AGENDA

La Vergne Planning Commission

November 28, 2023 at 6:00 PM

Planning Commission Report
Meeting: November 28, 2023

SHEET: C1.0

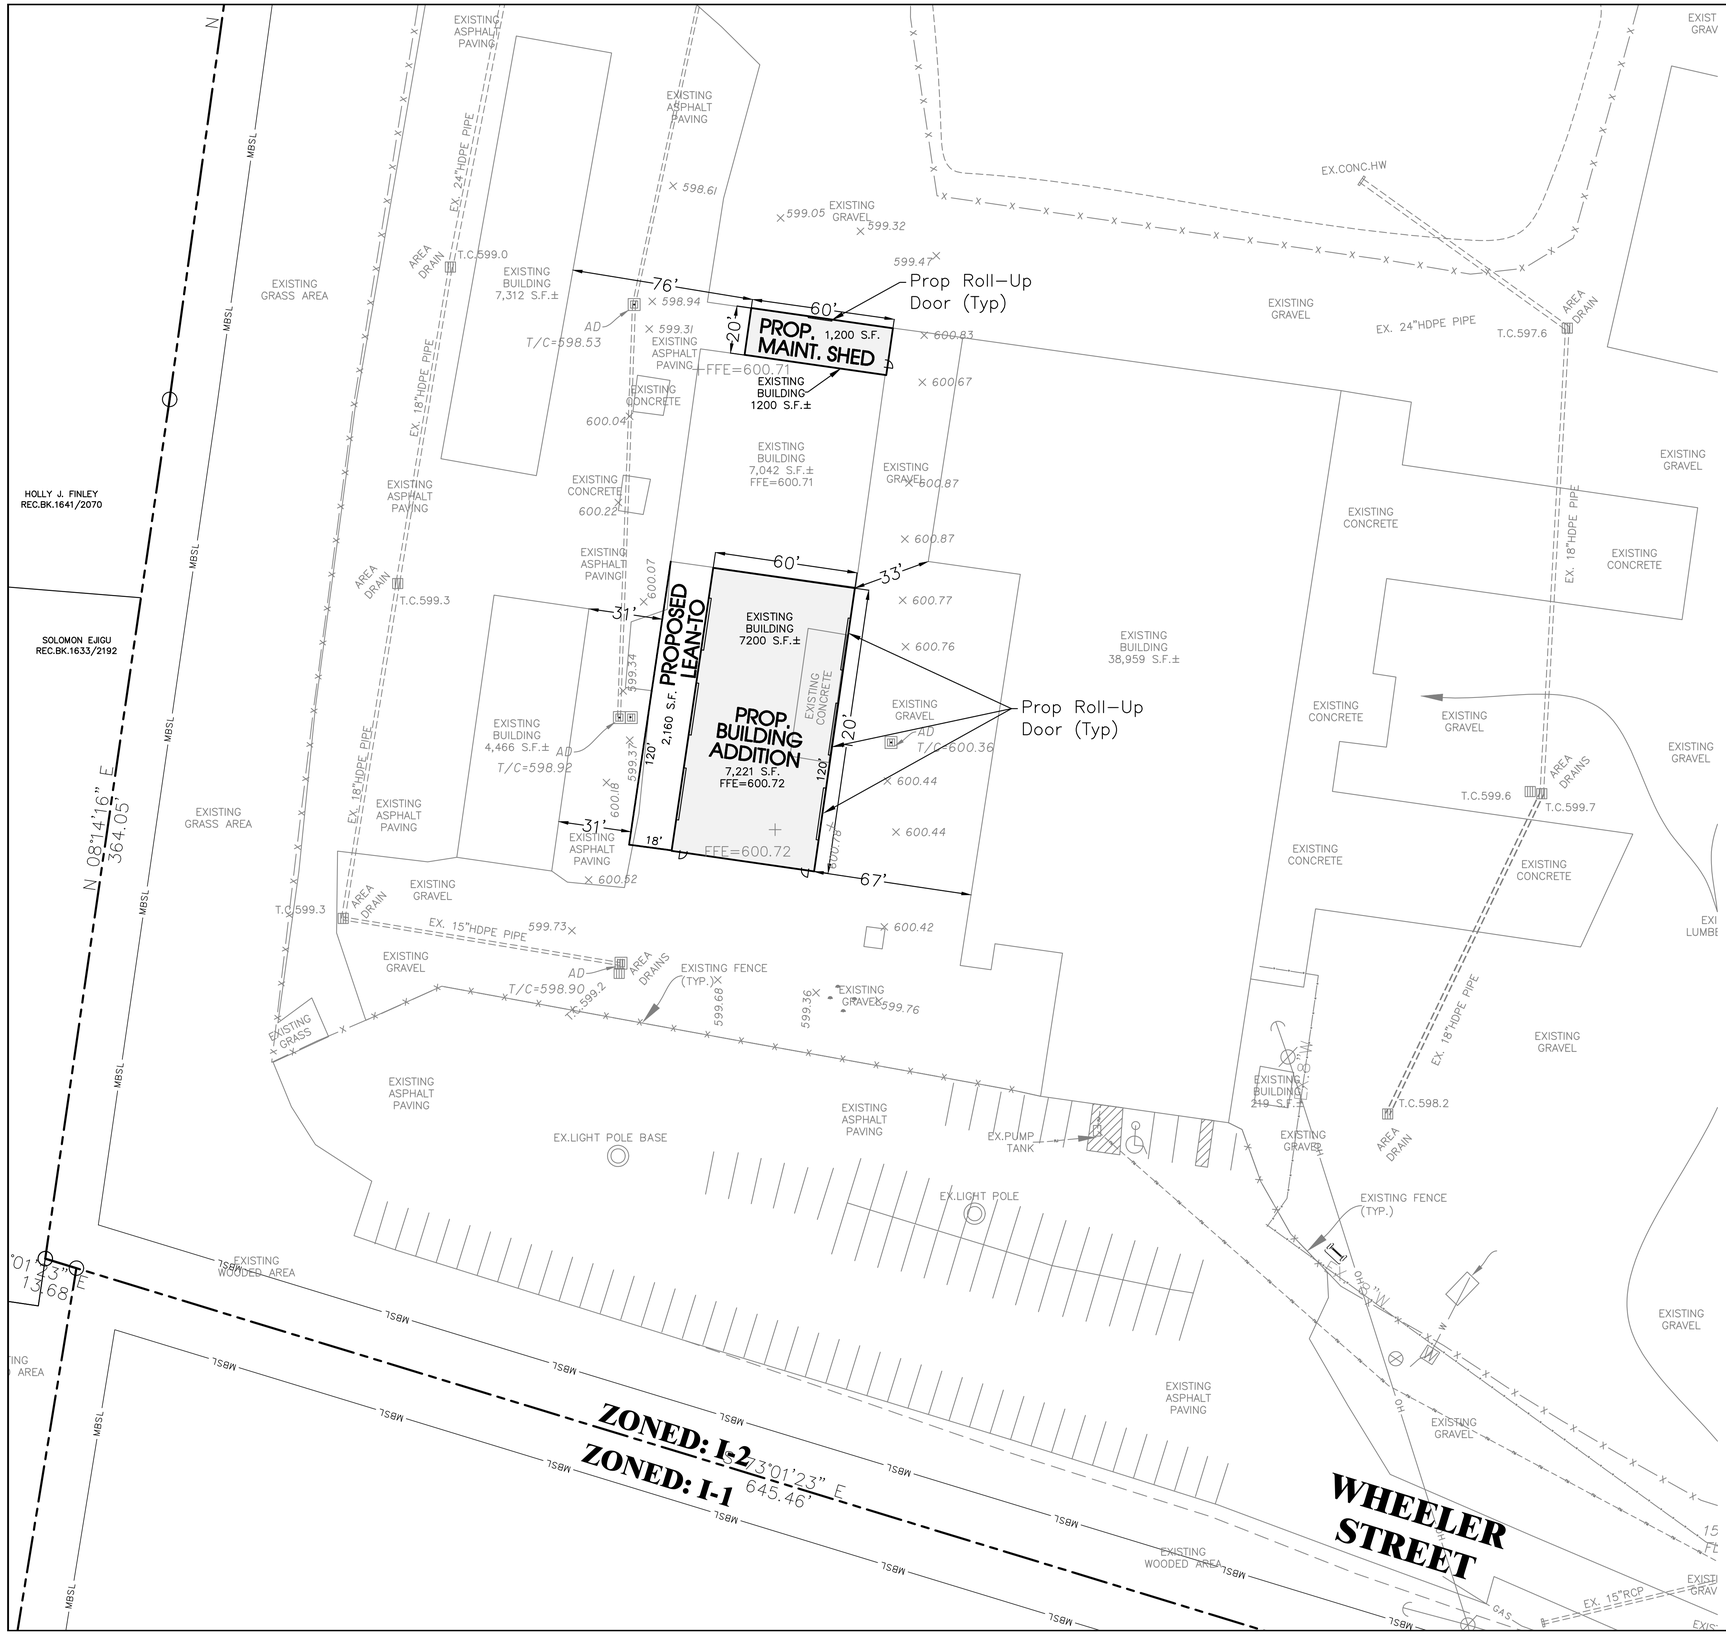
4. On Sheet C1.0, Outfall #1 is described as "Existing Detention Area" ands there is no outfall #2 listed in the table. There is, however, an Outfall #2 shown on the plan which appears to be at the existing detention area. Please clarify.

7. On sheet C1.0, show construction entrance coming off of existing asphalt
8. Provide water quality calculations or a description of why none are needed.

9.On sheet C4.0. Filtrexx is shown for both sediment control and concrete wash-out. It is not shown as sediment control on sheet C1.0 or C3.0. Please explain the purpose of that detail to make it clear to the contractor and our inspector when it might be used.

SHEET: C2.0

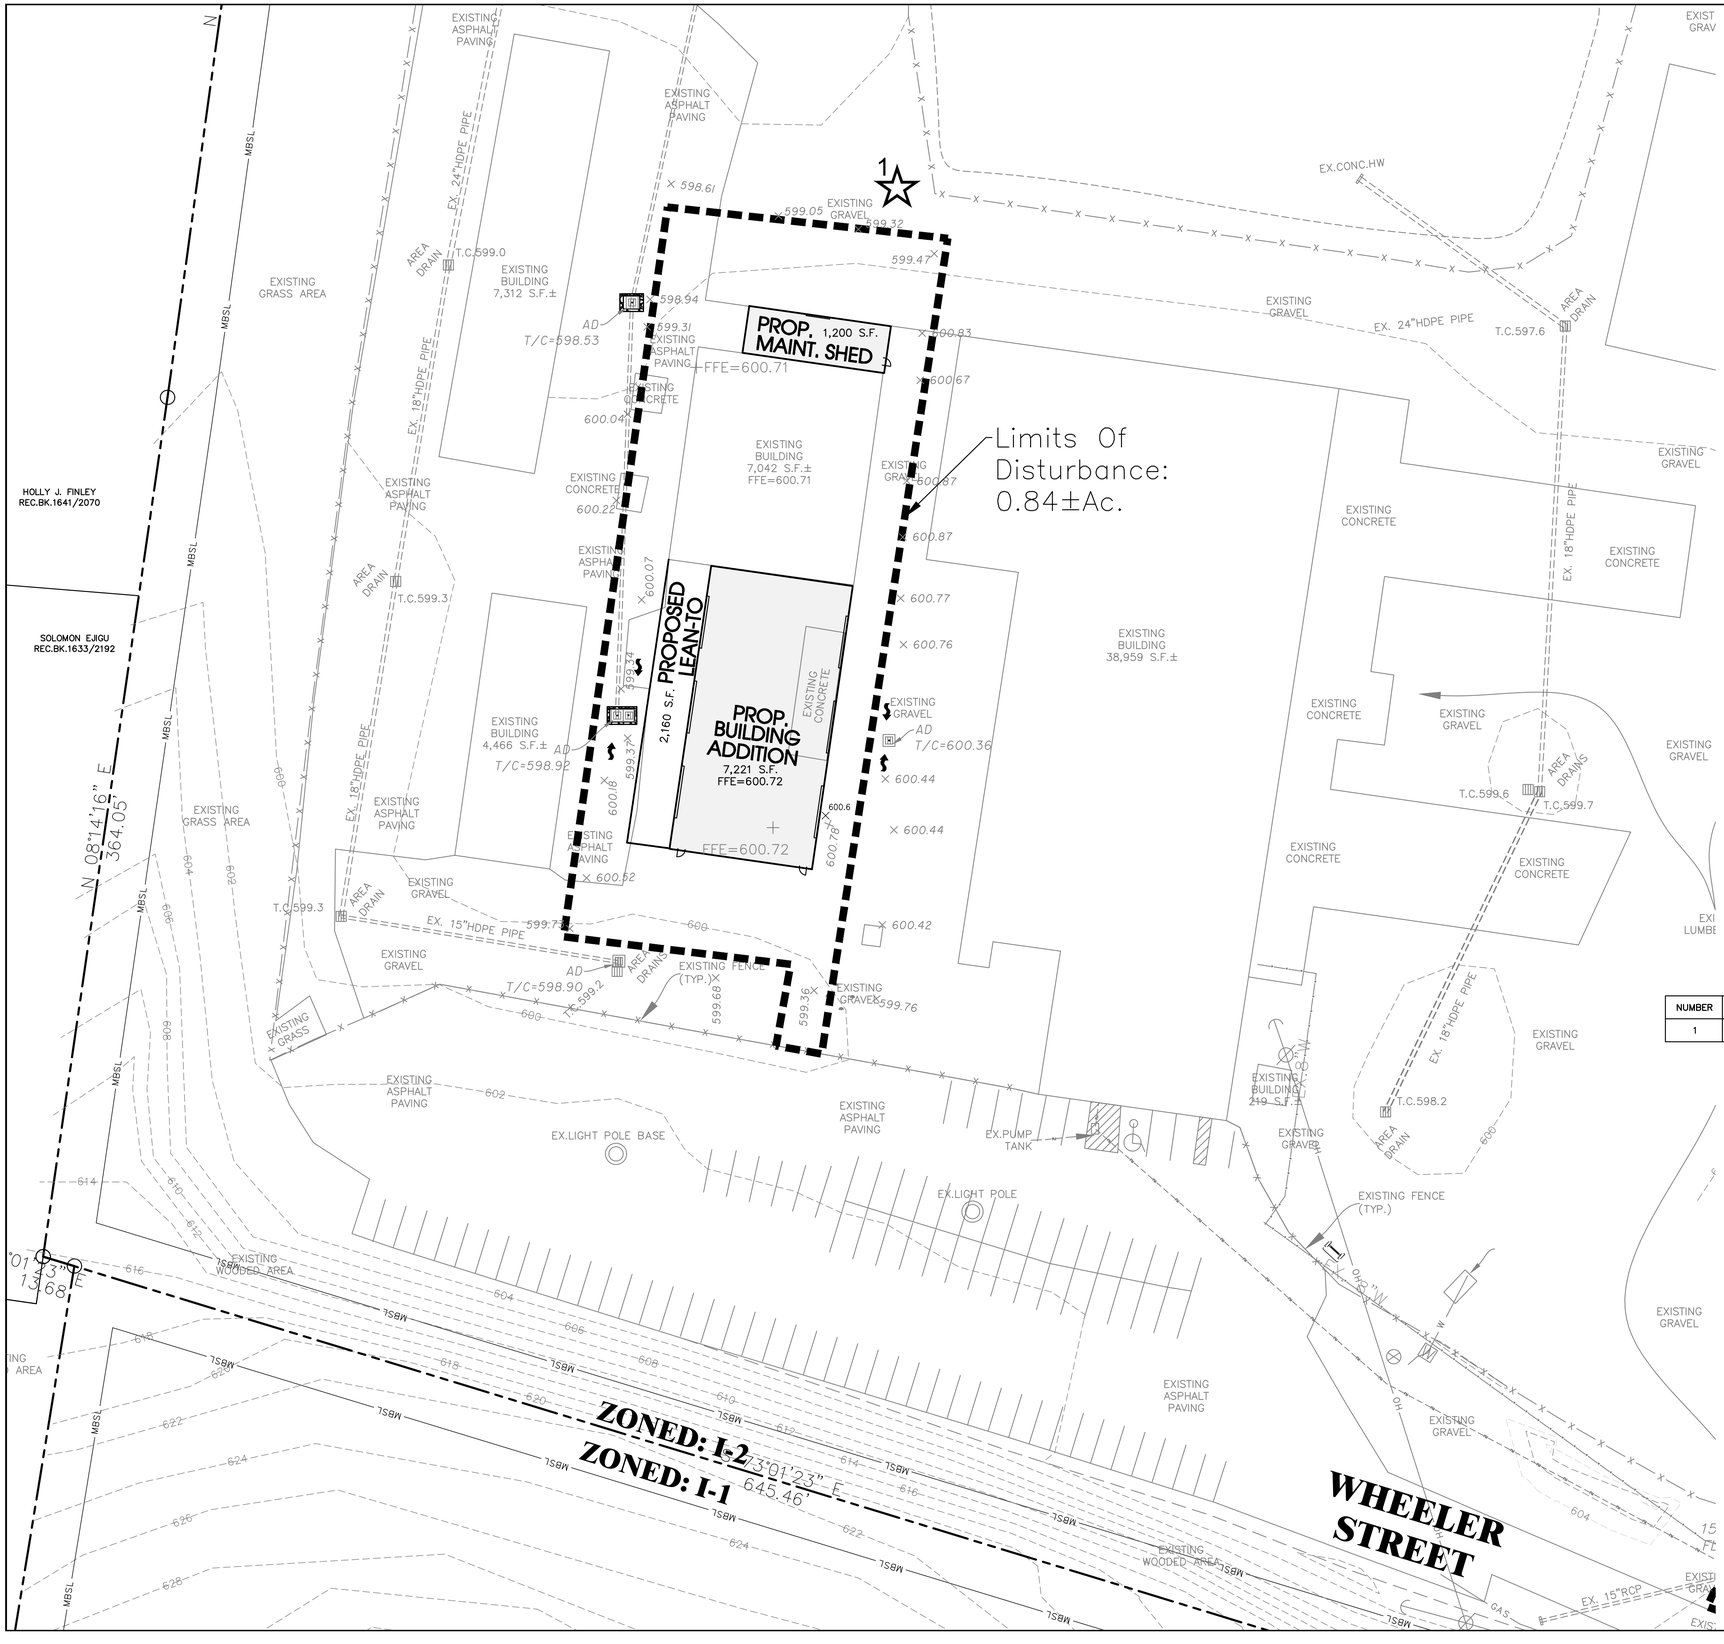
1. Sht C2.0 - Site and Utility Plan, does not show existing utilities.
2. Concept of what is being shown for construction is not clearly identified.
3. It appears 84 Lumber has hired a new engineer (SEC) to prepare plans to install the proposed saw shed previously being prepared by in-house, engineering staff.
4. Engineer needs shall put more work into this drawing set before Utility Engineer can review it.
5. A FH flow test was performed for this job and a water availability letter was prepared for this project. The results of this information is that the project needs an onsite tank for fire flow storage and a fire pump to meet fire flow sprinkler system requirements per previous Fire Sprinkler Engineer. Copies of the fire flow test and water availability letter can be obtained by contacting the Utility Engineer: Scott Tatalovich: 615-287-8739, statalovich@lavergnetn.gov.

DWG. No.
C-2.1

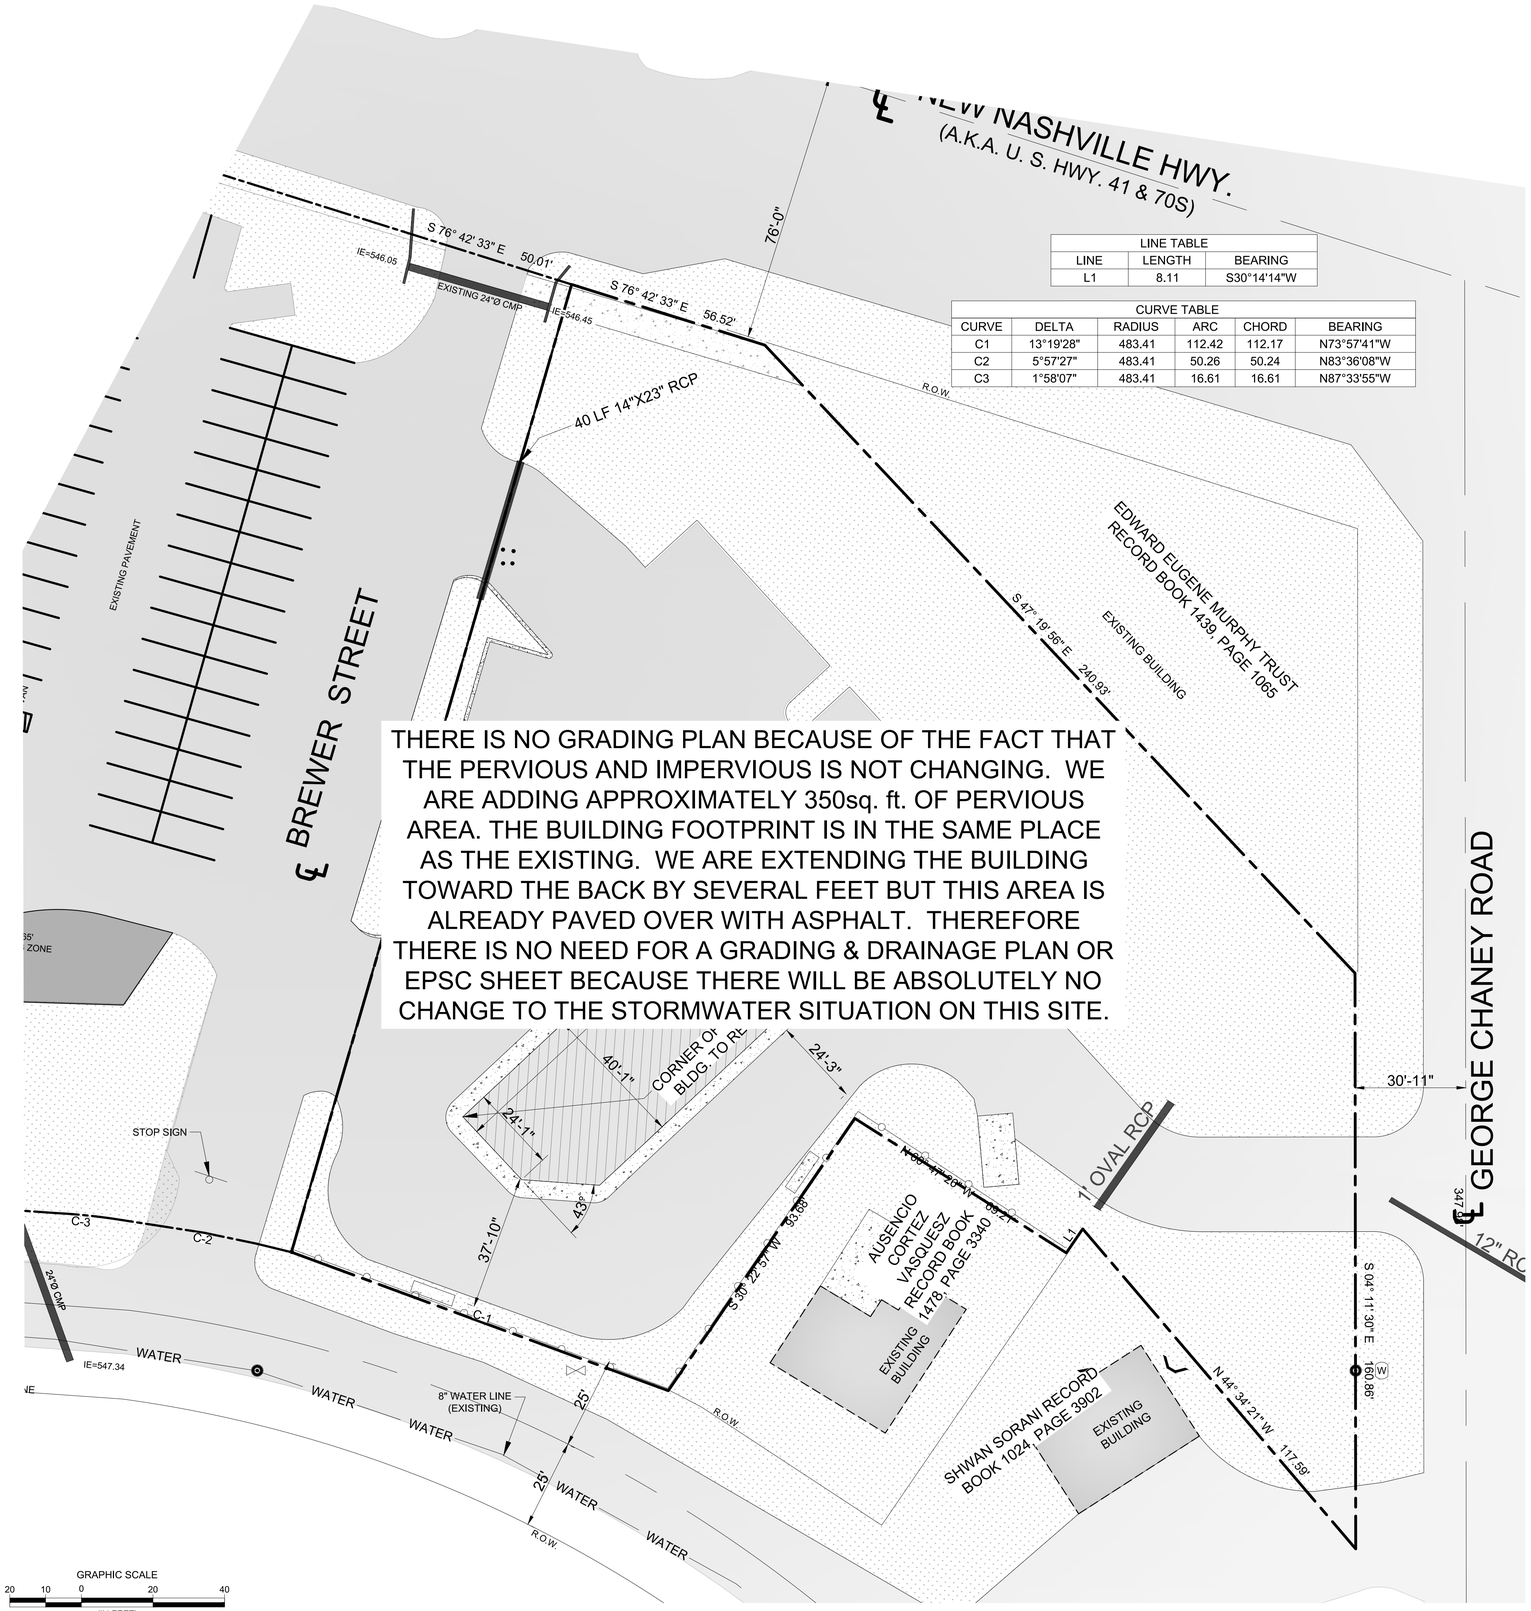
6. (Sheet C-2.1) Provide total driveway widths at the northern drive onto Brewer Street and the drive onto George Chaney Road.
7. (Sheet C-2.1)The dumpster screen is proposed to be exposed CMU with a wooden gate. The Planning Commission will review that proposal against requirements of the Murfreesboro Road Overlay District.

8. (Sheets C-2.0 and C-2.1) Please clarify which parking spaces are 19'-0" long and which are 19'-1" long. The spaces fronting on Murfreesboro Road are labeled at 19'-1" long and the ones in front of the building are labeled as 19'-0" long. The spaces along Brewer Street are unlabeled. Staff's previous assumption that the intent was for all spaces to be 19'-0" long was dispelled by the engineer's response to the previous comment. If different dimensions are provided, then all spaces must be labeled.
